Class 2 Permit Modification Request

Removal of Deteriorating/Non-Essential Water Level Monitoring Program Wells

**Waste Isolation Pilot Plant
Carlsbad, New Mexico**

WIPP Permit Number - NM4890139088-TSDF

Figure 1. Proposed Changes to Wells in Permit Figure L-14, *Groundwater Level Surveillance Wells*

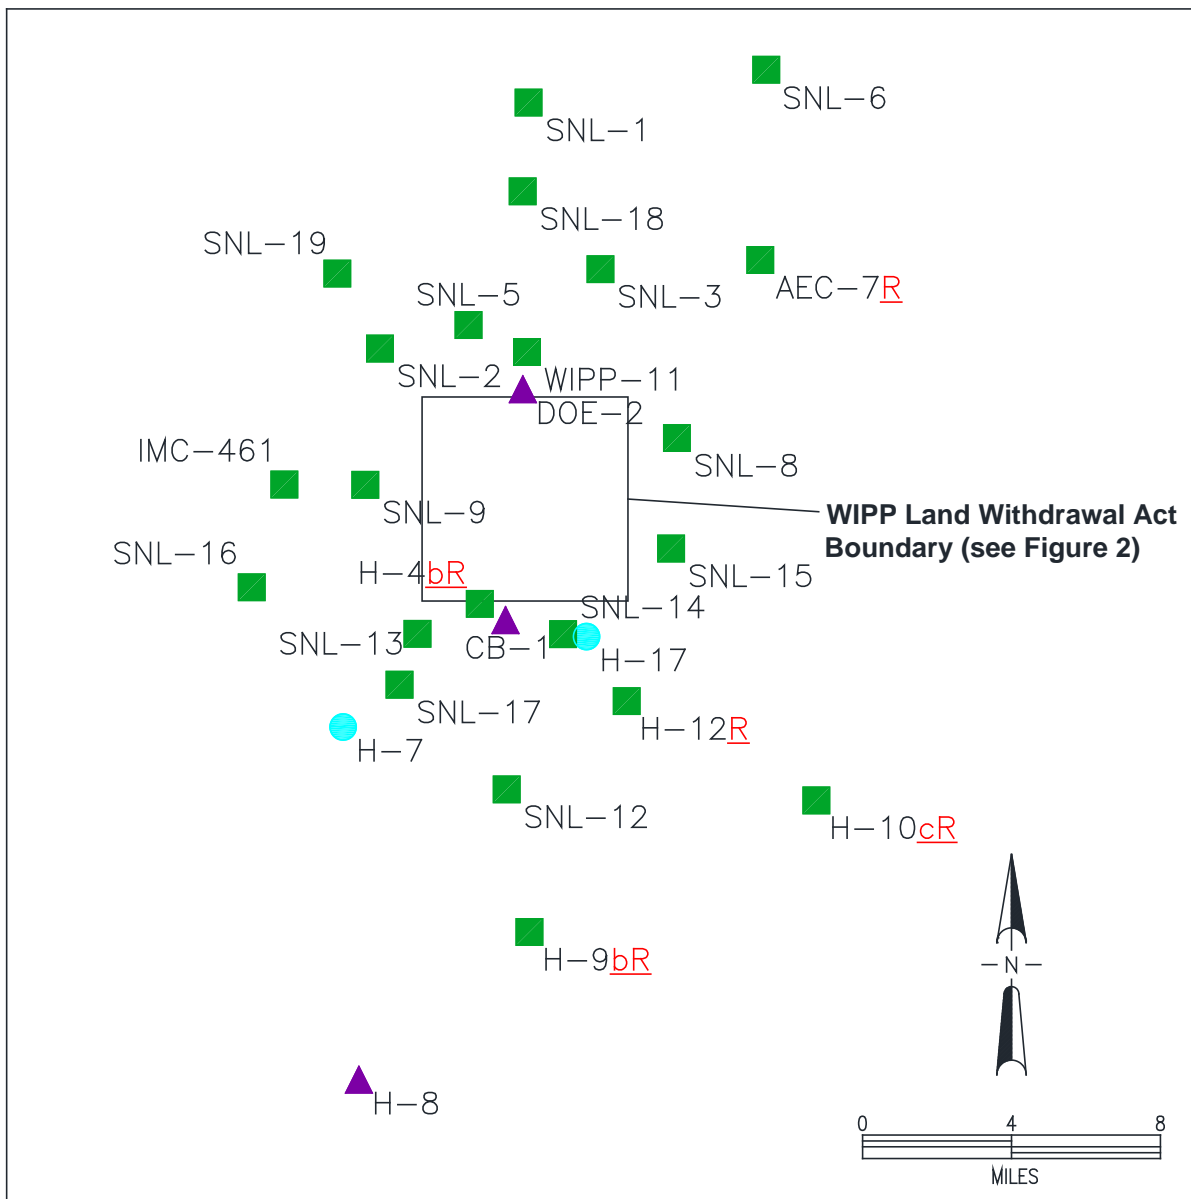
- Permit Attachment L, Figure L-14, *Groundwater Level Surveillance Wells*
 - Remove wells H-18, WIPP-18, H-14, DOE-2, CB-1, and H-8 (as shown in Figures 1 and 2).

- Modify the Exclusive Use Area boundary.
 - Delete “ASER 3-11-09” from the bottom right corner of the figure.
 - Change the well identification numbers (as shown in Figures 1 and 2) in the figure as follows:

- Change “AEC-7” to “AEC-7R”
 - Change “H-4” to “H-4bR”
 - Change “H-5” to “H-5b”
 - Change “H-6” to “H-6bR”
 - Change “H-9” to “H-9bR”
 - Change “H-10” to “H-10cR”

- Change “H-11b4” to “H-11b4R”
 - Change “H-12” to “H-12R”
 - Change “H-15” to “H-15R”
 - Change “H-19” to “H-19 pad”

- Permit Attachment L, Figure L-14, *Groundwater Level Surveillance Wells*
 - Wells H-18, WIPP-18, H-14, DOE-2, CB-1, and H-8 need to be removed from this figure because they monitor the Bell Canyon Formation and the Magenta Dolomite Member of the Rustler Formation; the WLMP only consists of wells monitoring the Culebra, and as a result, wells H-18, WIPP-18, H-14, DOE-2, CB-1, and H-8 are not listed in Permit Attachment L, Table L-4. These wells had been included in the figure because they were part of the Annual Site Environmental Report in 2009. These wells need to be removed to provide an update to this figure and to assure accuracy and consistency with Table L-4.

- The Exclusive Use Area requires modification to more accurately depict the boundary.
 - “ASER 3-11-09” needs to be deleted from the bottom corner of the figure because, with the proposed changes to the figure, it will become an incorrect reference.

- Some of the well identification numbers need to be changed to ensure consistency with the identification numbers in Table L-4 and in the well permits issued by the New Mexico Office of the State Engineer, as listed in Permit Attachment B, *Hazardous Waste Permit Application Part A*, Appendix B1, *Other Environmental Permits*.

Figure L-2
WIPP Facility Boundaries Showing 16-square-Mile Land Withdrawal Boundary

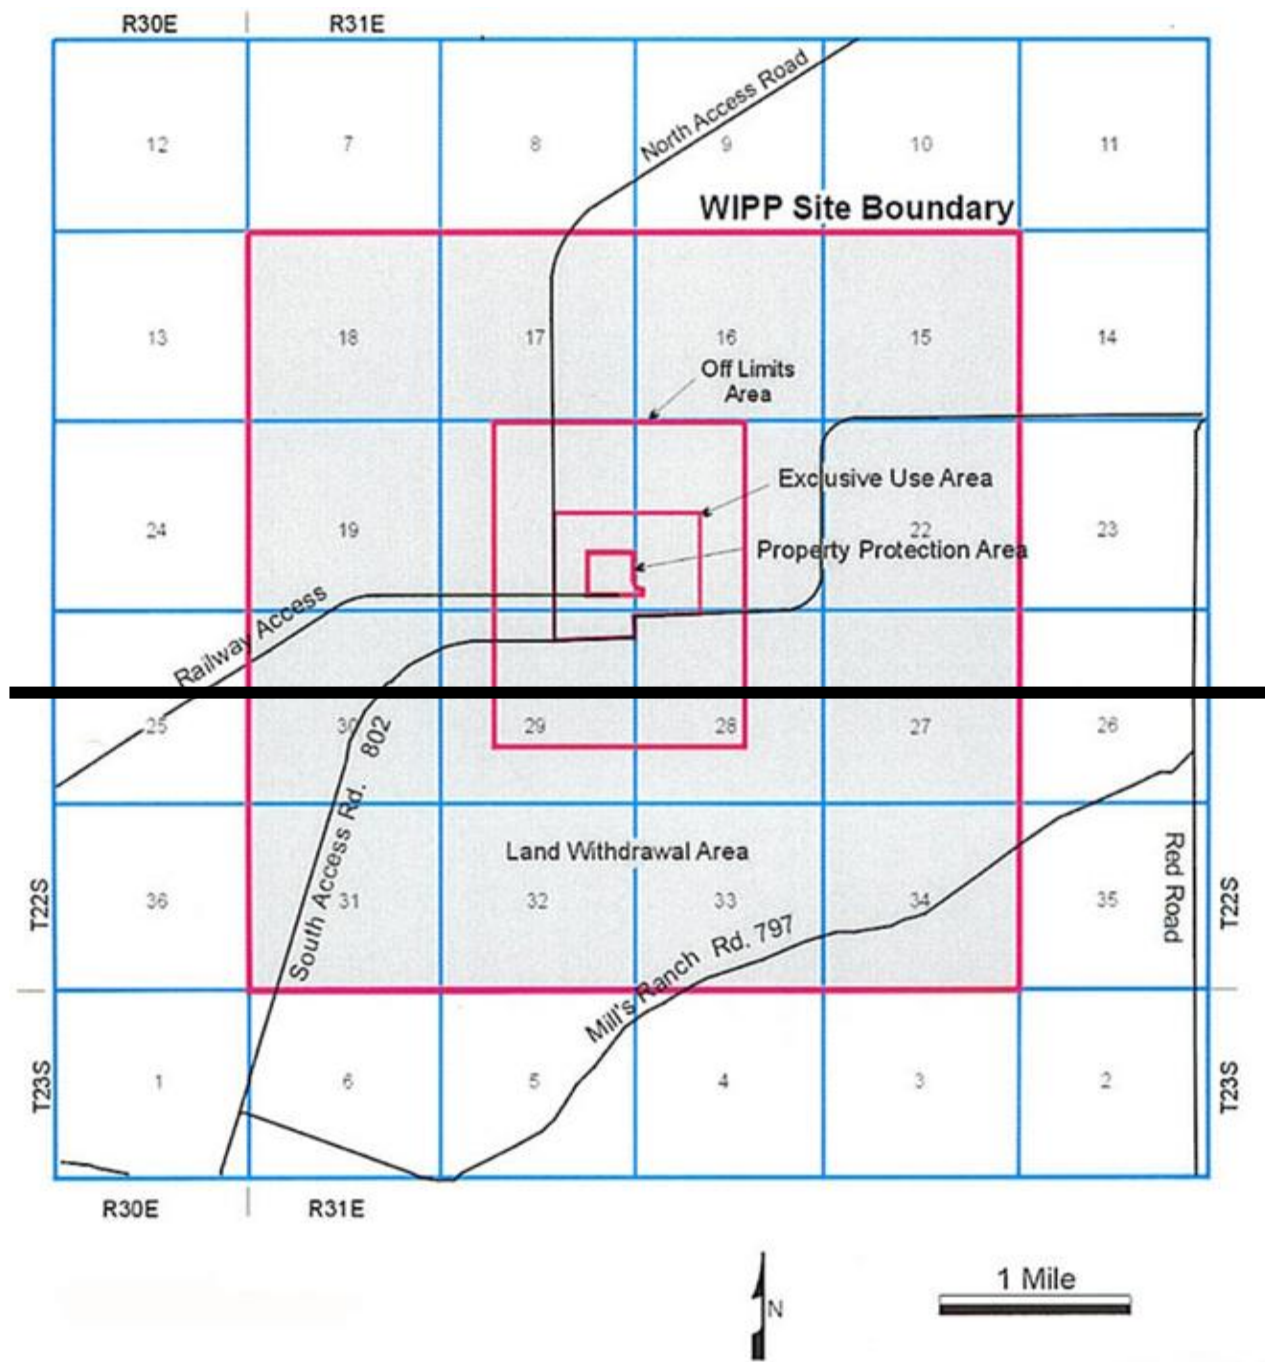
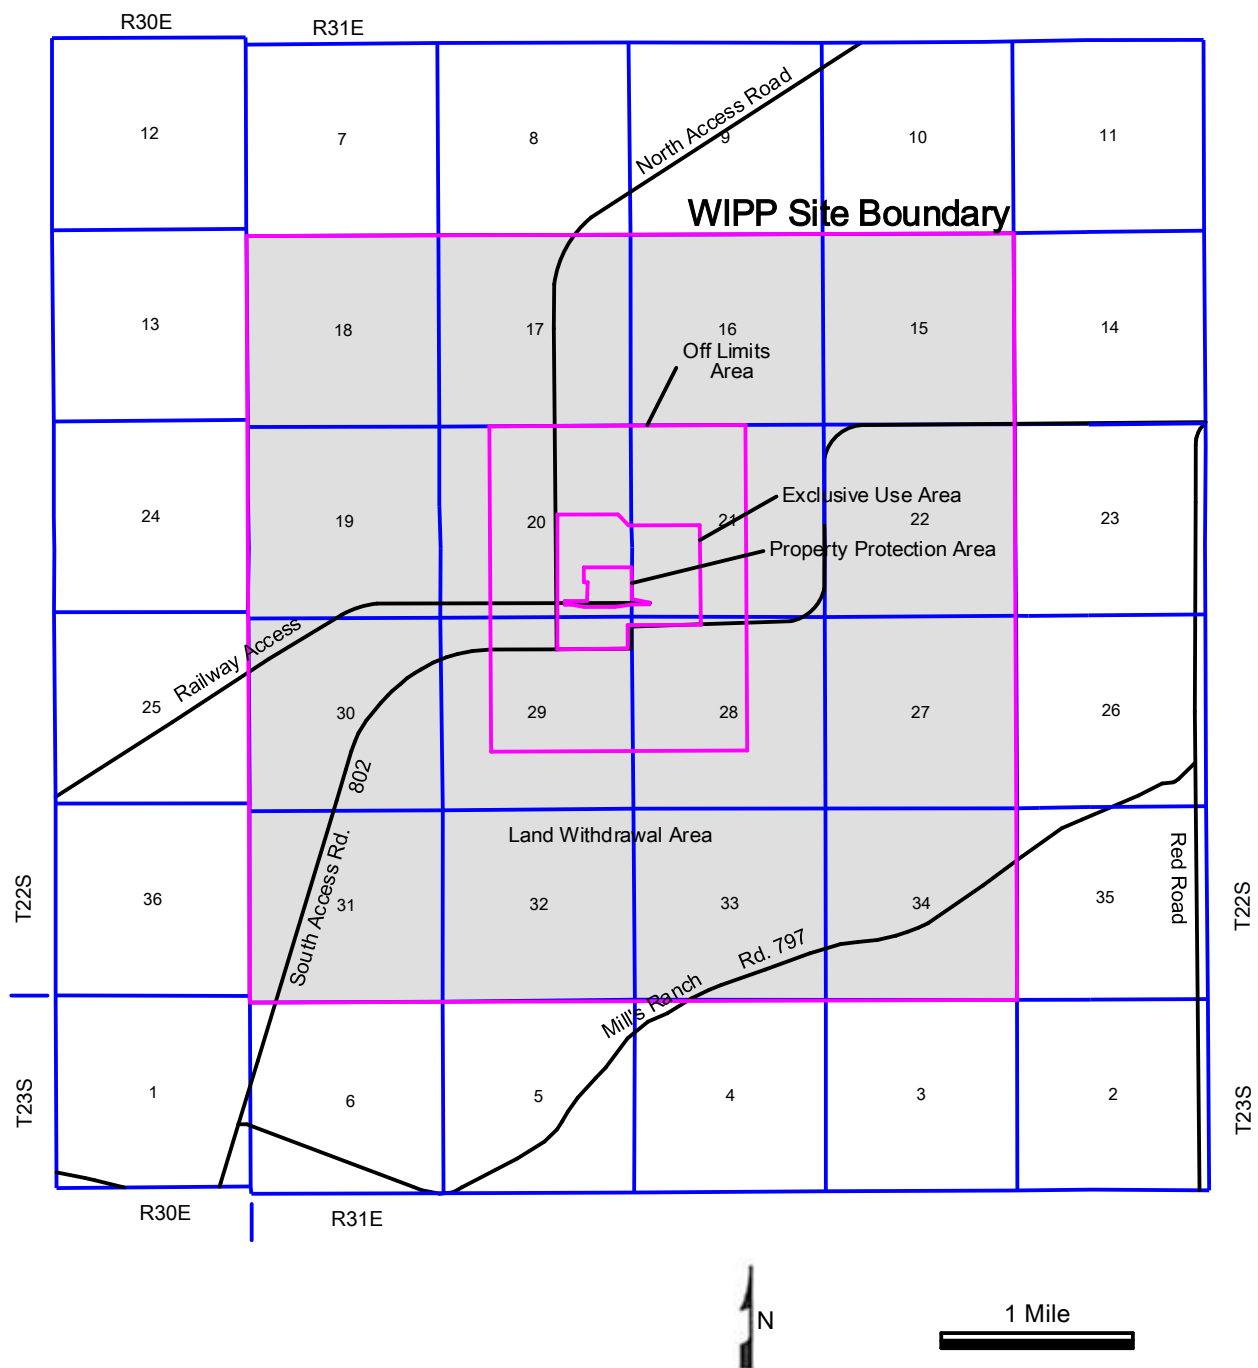
- Change “SNL-03” to “SNL-3”
 - Change “SNL-05” to “SNL-5”
 - Change “SNL-06” to “SNL-6”
 - Change “SNL-08” to “SNL-8”
 - Change “SNL-09” to “SNL-9”
- Permit Attachment L, Figure L-2, *WIPP Facility Boundaries Showing 16-square-Mile Land Withdrawal Boundary* – Modify the Exclusive Use Area and Property Protection Area boundaries and add section labels for sections “20” and “21.”

- Permit Attachment L, Figure L-2, *WIPP Facility Boundaries Showing 16-square-Mile Land Withdrawal Boundary* – The Exclusive Use Area and Property Protection Area require modification to more accurately depict the boundaries and ensure consistency with the Property Protection Area boundary in Figures L-6 and L-14. In addition, missing section labels need to be added for sections “20” and “21” for completeness.

Permit Attachment L, Figure L-2, <i>WIPP Facility Boundaries Showing 16-square-Mile Land Withdrawal Boundary</i>	Moved the Property Protection Area to the west. Moved the north Exclusive Use Area fence line to the north.
Permit Attachment L, Figure L-5, <i>Culebra Freshwater-Head Potentiometric Surface</i>	Deleted figure.
Permit Attachment L, Figure L-6, <i>Detection Monitoring Well Locations</i>	Moved the north Exclusive Use Area fence line to the north. Updated figure labels for "WIPP Site," "Exclusive Use Area," "Property Protection Area," "Off Limits Area" and added section labels for sections "20" and "21."
Permit Attachment L, Figure L-14, <i>Groundwater Level Surveillance Wells (inset represents the groundwater surveillance wells in WIPP Land Withdrawal Area)</i>	Deleted "H-18." Deleted "WIPP-18." Deleted "H-14." Deleted "DOE-2." Deleted "CB-1." Deleted "H-8." Moved the north Exclusive Use Area fence line to the north. Changed "AEC-7" to "AEC-7R."

Figure L-5
Culobra Freshwater-Head Potentiometric Surface

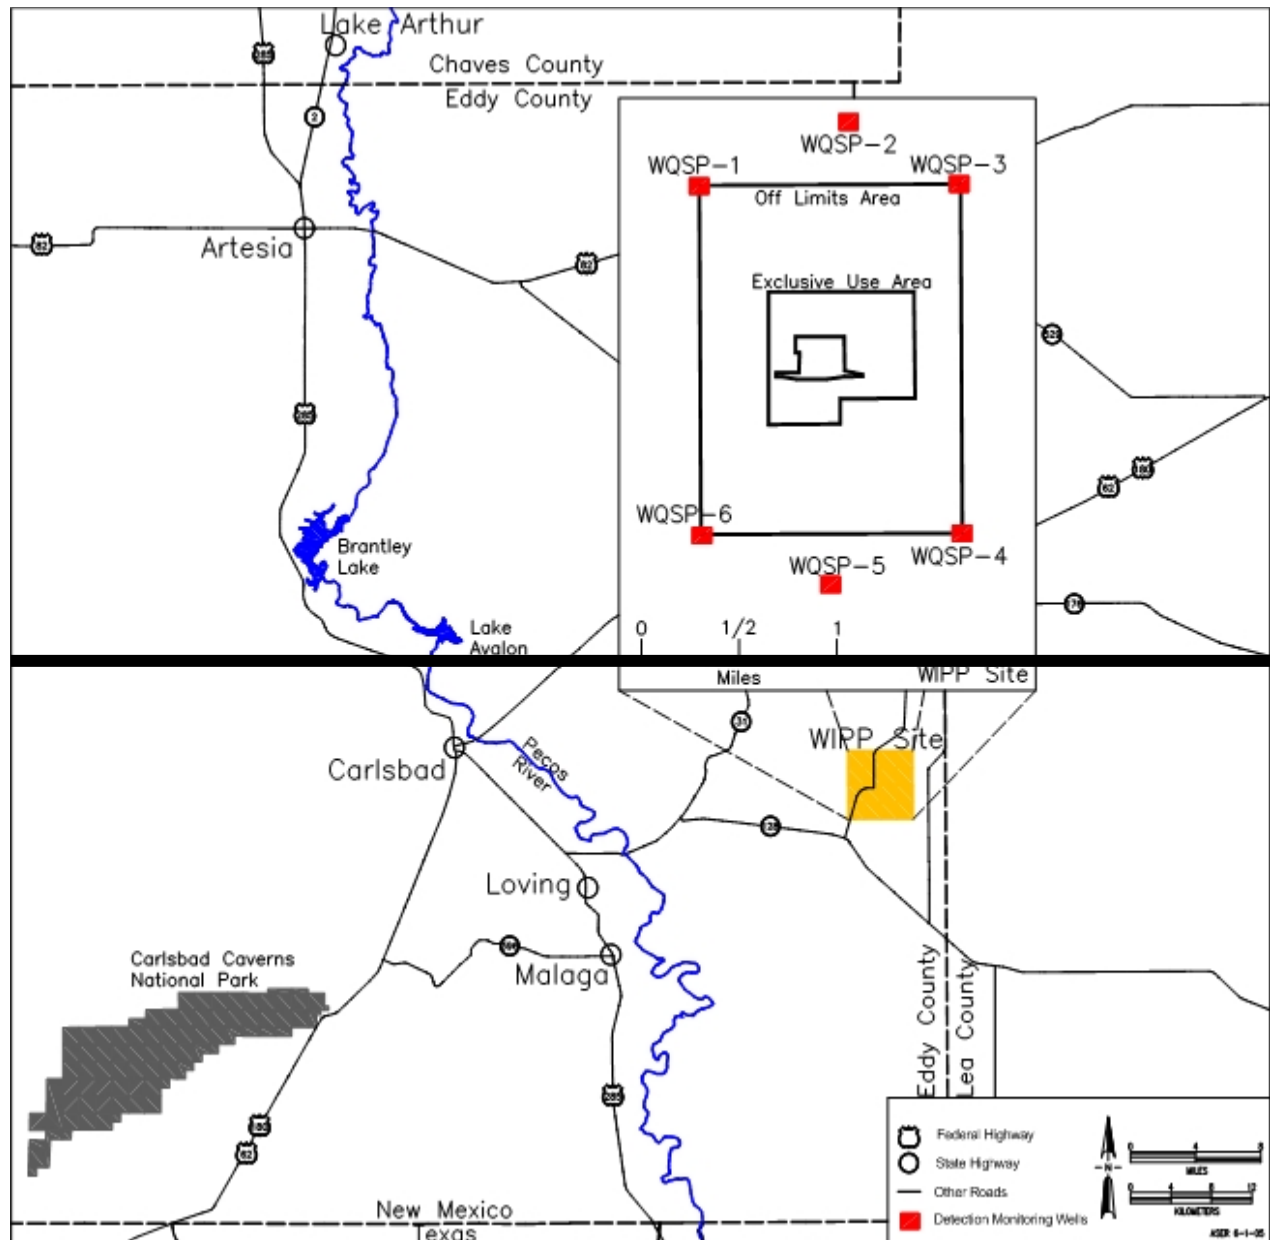
- Permit Attachment L, Figure L-5, *Culebra Freshwater-Head Potentiometric Surface* – Delete this figure.
- Permit Attachment L, Figure L-6, *Detection Monitoring Well Locations* – Modify the Exclusive Use Area boundary and the figure labels for “WIPP Site,” “Exclusive Use Area,” “Property Protection Area” and “Off Limits Area.”

- Permit Attachment L, Figure L-5, *Culebra Freshwater-Head Potentiometric Surface* – This figure is proposed for removal from the Permit since this figure is obsolete and is updated in the Annual Culebra Groundwater Report, which is provided to the NMED in accordance with Permit Part 5, Section 5.10.2.1, *Data Evaluation Results*.

Figure L-6
Detection Monitoring Well Locations

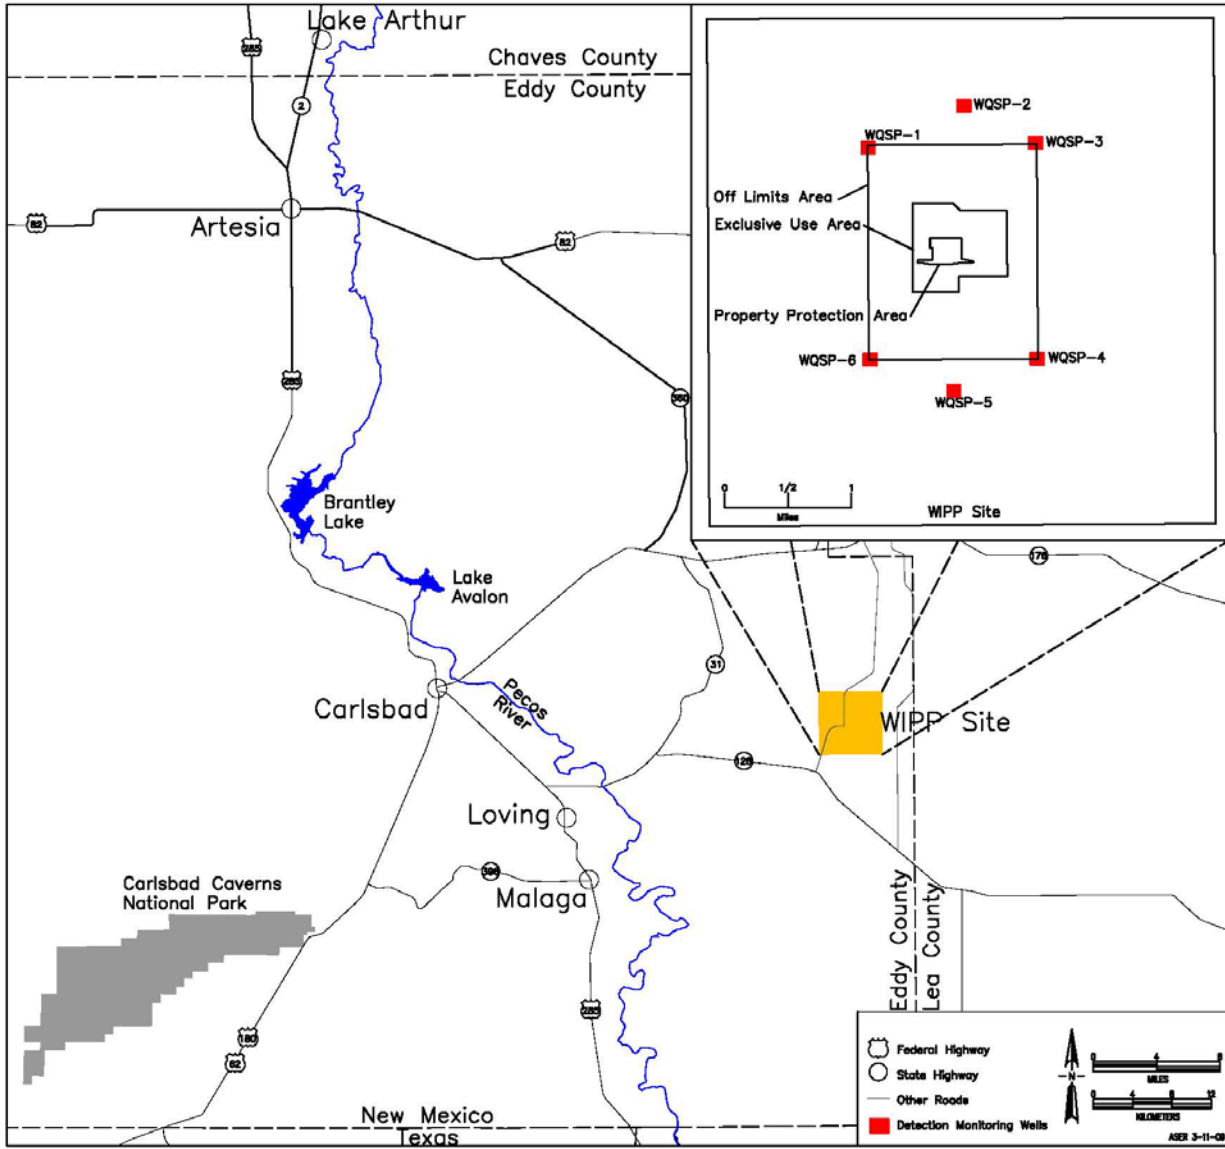
- Permit Attachment L, Figure L-6, *Detection Monitoring Well Locations* – The Exclusive Use Area boundary requires revision to provide a more accurate depiction, and the figure labels for “WIPP Site,” “Exclusive Use Area,” “Property Protection Area” and “Off Limits Area.” These changes need to be made to ensure accuracy of the Permit.

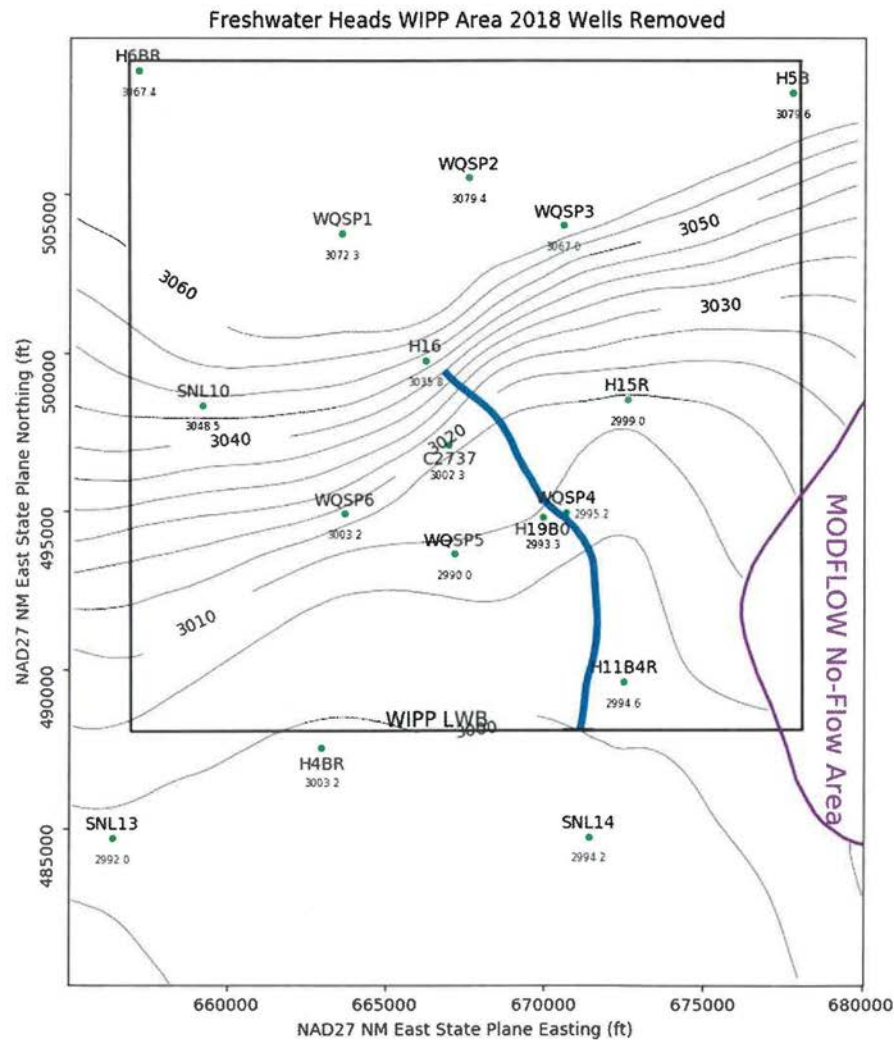
Per your request (email attached), the contour map presented below in Figure 1 was created utilizing data from the 2018 Culebra potentiometric surface map reported in the *Analysis Report for Preparation of the 2018 Culebra Potentiometric Surface Contour Map* (Hayes, 2019), but with seven wells, ERDA-9, H-2b2, H-3b2, H-7b1, H-17, WIPP-13, and WIPP-19, removed from the analysis. This analysis is consistent with the Kuhlman, 2010 *Analysis Report AP-111* that discussed the Culebra water level monitoring network design and the minimal impact of removing these seven wells that were proposed for plugging and abandonment.

The blue line in Figure 1 corresponds to the calculated path a water particle would take through the Culebra from the coordinates corresponding to the WIPP waste handling shaft to the Land Withdrawal Boundary. The particle track has a path length of 13355 ft (4070 m). The calculated travel time of the particle is 6019 years with an average speed of 2.2 ft/year (0.68 m/year). The original particle track length presented in Figure 2 had a path length of 13355 ft (4070 m) a calculated travel time of 5979 years and an average speed of 2.2 ft/year (0.68 m/year).
